# UNITED STATES PATENT AND TRADEMARK OFFICE

10/824,489

<b>Office Action Summary</b>	<b>Application No.</b> 10/824,489	<b>Applicant(s)</b> REBLEWSKI, FREDERIC	
	<b>Examiner</b> AKASH SAXENA	<b>Art Unit</b> 2128

**DETAILED ACTION**

***FIGURE 7***

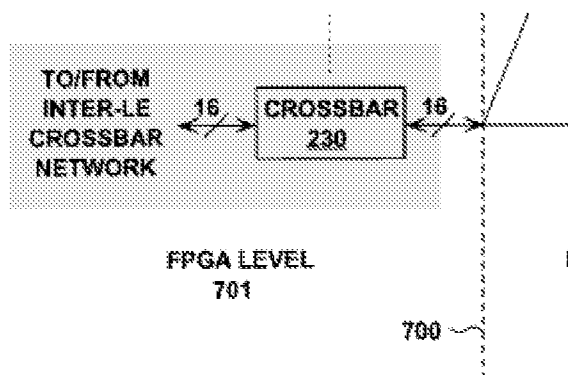
Independent claim 4 as amended recites a third reconfigurable interconnect stage - configurable to receive a second plurality of outputs of a second reconfigurable interconnect stage and to provide outputs back to inputs of clusters that include simulation engines. An example of this configuration is described in Applicant's specification, e.g., at p. 17, paragraph 52. The Office Action compares the third reconfigurable stage with crossbar 230 on the right side of Fig. 7 in Barbier, and the clusters of simulation engines with LE array 102 of Barbier. However, crossbar 230 on the right side of Fig. 7 does not provide outputs back to LE array 102. Thus, Barbier does not teach or suggest the third reconfigurable interconnect stage as now claimed. For at least this reason, it is submitted that amended claim 4 is allowable over Barbier.

**(Response 2)** As can be clearly seen the element 230 has a bidirectional arrow to the LE array further stating to-from LE array, thereby meeting the argued limitation.

Fig.7 Element 631 having outputs to Element 230 on left, 640 and 230 on right), wherein the first set of outputs from the second reconfigurable interconnect stage are coupled to first subset of the inputs of the first reconfigurable interconnect stage via plurality of feedback paths (Barbier: Fig.7 Element 631 path to 230 on the left); and a third reconfigurable interconnect stage having a plurality of inputs coupled to a second subset of the outputs from the second reconfigurable interconnect stage (Barbier: Fig.7 Element 230 on right of Element 631 as third reconfigurable interconnect) wherein the plurality of feedback paths each couples one of the outputs of the second reconfigurable interconnect stage to one of the inputs of the first reconfigurable interconnect stage without passing through the third reconfigurable interconnect stage (Barbier: Fig.7) as seen feedback from second reconfigurable interconnect (Barbier: Fig.7 element 631) to first reconfigurable interconnect (Barbier: Fig.7 Element 230 on the left) is direct and does not pass through third reconfigurable interconnect (Barbier: Fig.7 Element 230 on the right).

Barbier teaches outputs of the second reconfigurable interconnect stage are coupled to the inputs of the third reconfigurable interconnect stage using a butterfly topology (Barbier: Fig.7).
